Date: 27 June 2004
 To: T10 Technical Committee and SNIA OSD TWG
 From: Ralph O. Weber
 Subject: Rewrite of OSD Security and Policy/Storage Manager Models

Summary

The document shows all the changes to OSD r09 needed to:

Figure 1 — Example OSD Configuration

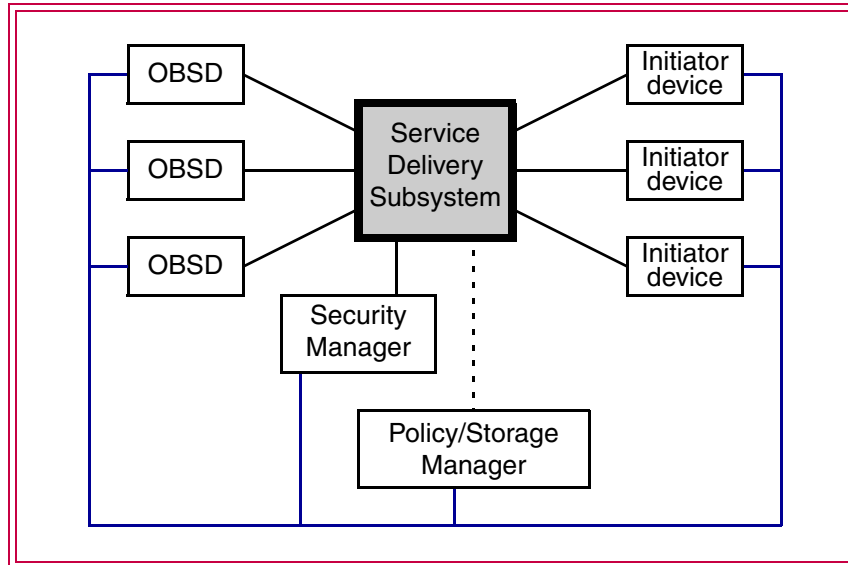
- r1 Contains the same normative text as r0, but the strikeouts are removed
- r2 Example configuration figure cleaned up and used blue lines for connections that do not use the service delivery subsystem. Moves the communications security requirements to the security manager Trust Assumptions subclause. Updates the security threats table to cover non-secure channels. Adds prototype CDB definition with changes resulting from the model split between Capabilities (aka Policy/Storage Management) and Credentials (aka Security).

Application clients using multiple SCSI initiator ports share ~~and~~ directly access an OBSD (see 3.1.26) via the service delivery subsystem. The service delivery subsystem is used by the components in the OSD model, except possibly the ~~policy/storage manager and/or~~ security manager, to intercommunicate. The OSD security model (see 4.9) does not require the service delivery subsystem to provide security-related services (i.e., authentication and ~~confidentiality data-privacy~~), but is designed to take advantage of whatever security-related services are provided.

The policy/storage manager (see 4.x), if present, ~~coordinates access constraints between OSD device servers and application clients, preparing the capabilities application clients place in CDBs to gain access to OSD objects and command functions. maintains storage policies in a manner that is outside the scope of this standard.~~

The security manager (see 4.9), if present, ~~coordinates access~~ ~~secures capabilities in cryptographically protected credentials~~ ~~between~~ for OSD device servers and application clients.

The ~~policy/storage manager and~~ security manager may reside in the OBSDs, in applications clients, or as a separate entities.

The ~~policy/storage manager and~~ security manager may use the service delivery subsystem and be an application client, but ~~they the security manager~~ also may use another mechanism to communicate with the OSD device servers and application clients. ~~Security-related requirements on the communications mechanisms used by the security manager are described in 4.9.2~~

Figure 2 — OSD security model transactions

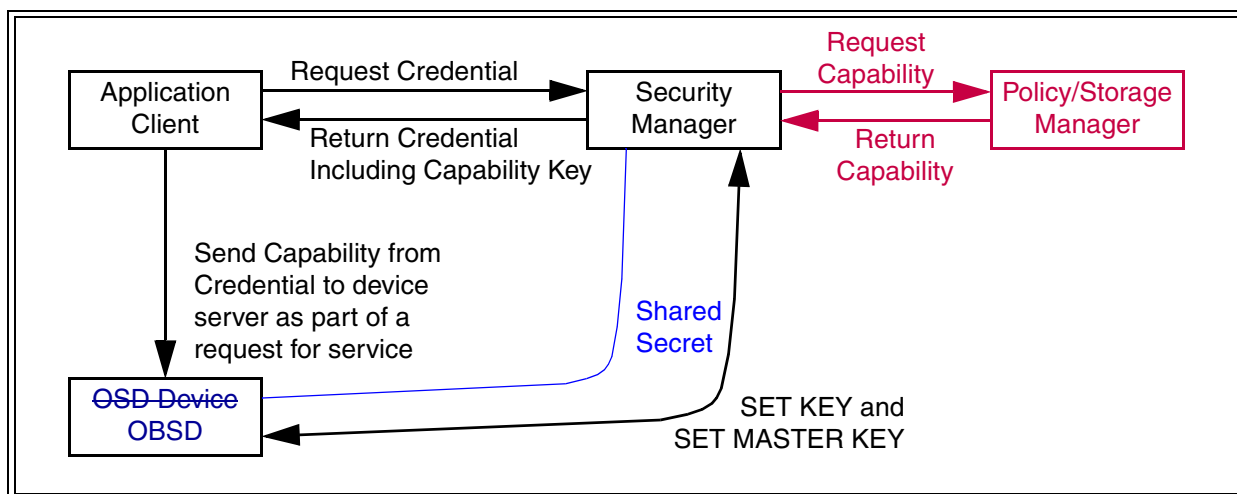
The security manager generates credentials, **including capabilities prepared by the policy/storage manager**, for authorized application clients at the request of an application client. The security manager returns a capability key with each credential. The credential gives the application client access to specific OSD components. The capability key allows the application client and device server to authenticate the commands and data they exchange with an integrity check value (see 4.9.7).
